# Comal County Environmental Health OSSF Inspection Sheet

## **Permit of Authorization to Construct an On-Site Sewage Facility Permit Valid For One Year From Date Issued**

Permit Number: 117702  
Issued This Date: 10/01/2024  
This permit is hereby given to: Salvador Cruz

2028 LIVE OAK DR  
CANYON LAKE, TX 78133

CRUZ SALVADOR  
2028 LIVE OAK DR  
CANYON LAKE, TX 78133  
TAMARACK SHORES SECTION II  
LOT 83 AND 84  
COMAL COUNTY

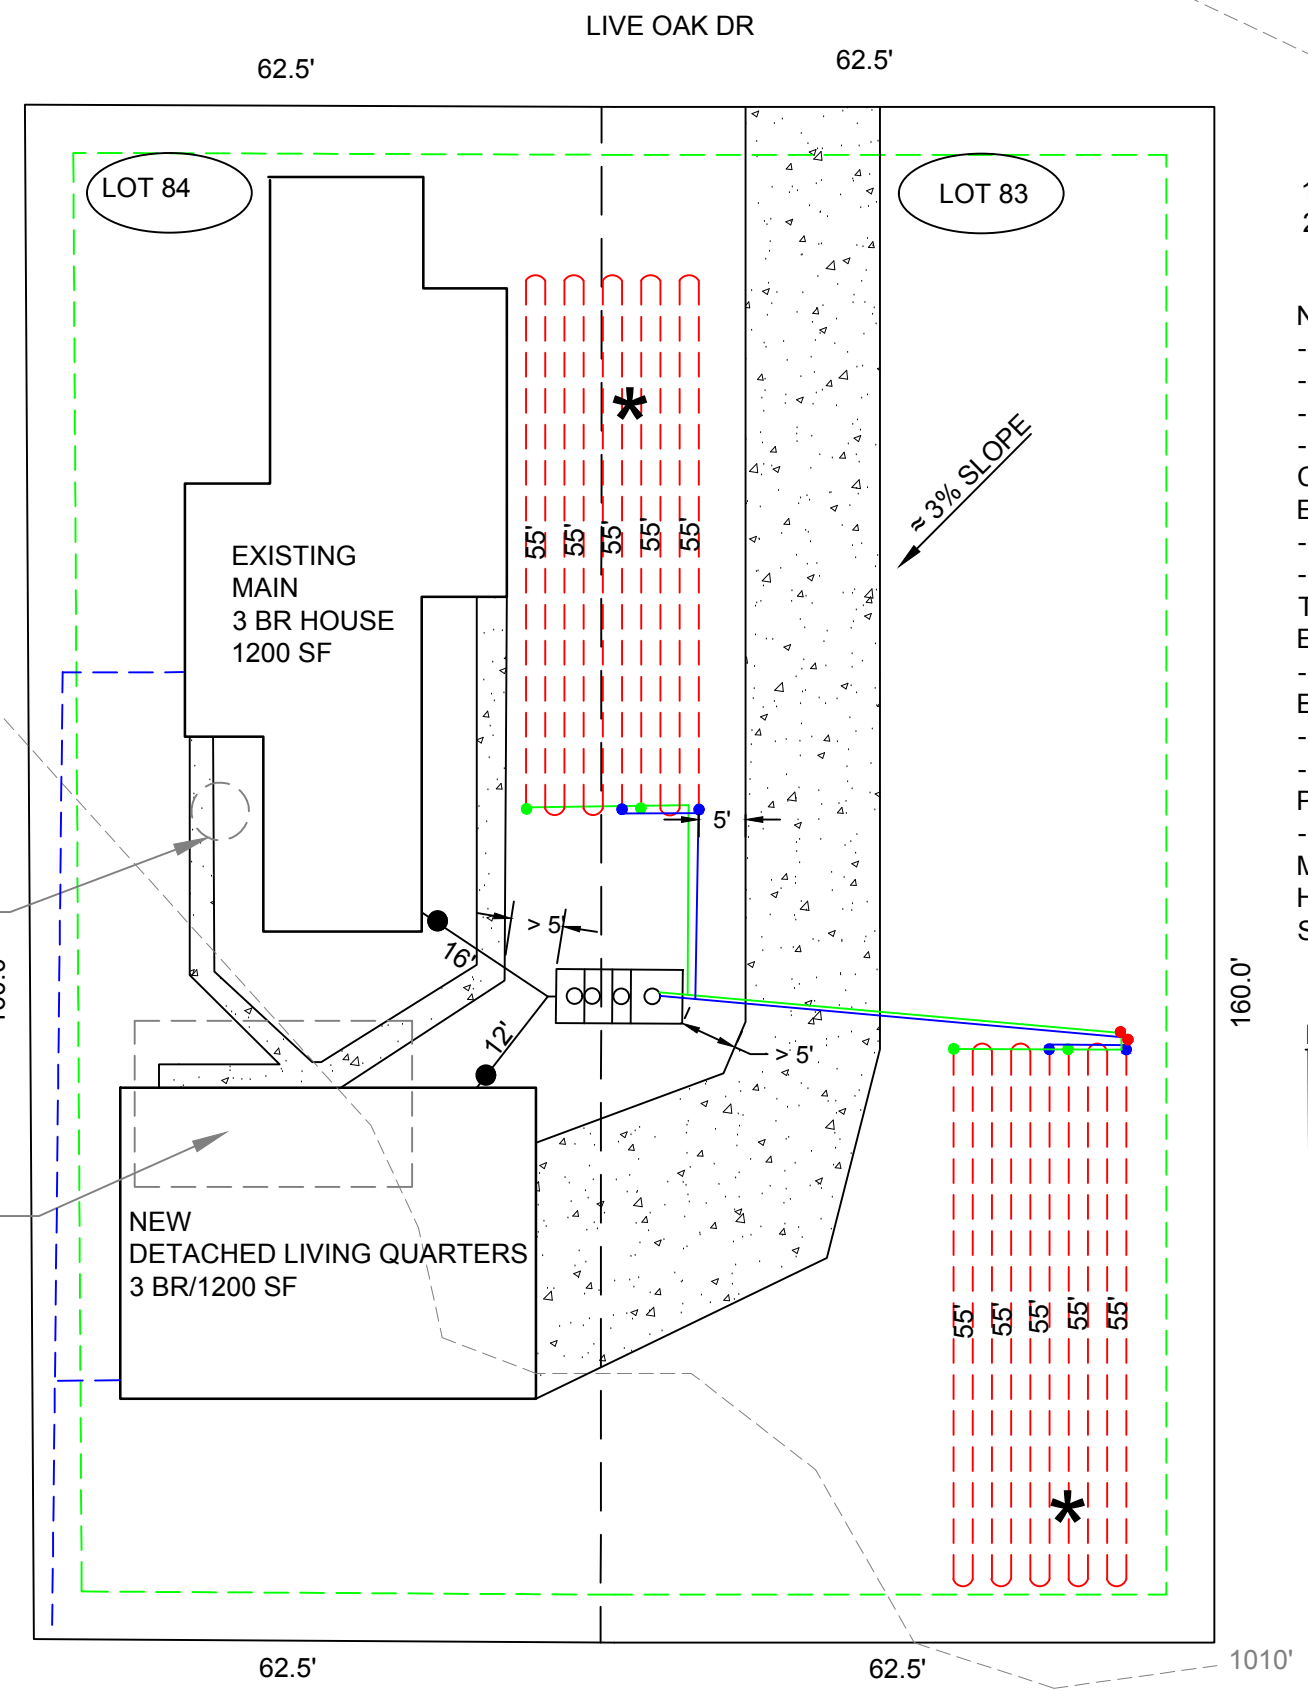
12/12/24 CA: Revision for pressure gauge in lieu of regulator system operational field to design no tight lines or sanitary tee existing system not abandoned will need to provide pump receipt and verify crush. Leave tight lines and connection exposed to verify sleeving and connection

3/5/25 CA: Tightline from main structure not sleeved drip lines have become uncovered not connected to detached structure unable to verify seed need pump receipt and re inspection fee Regulator installed

3/7/25 CA: Field covered and seeded tightline sleeved. Not connected to second structure

4/1/25 CA: Second structure connected
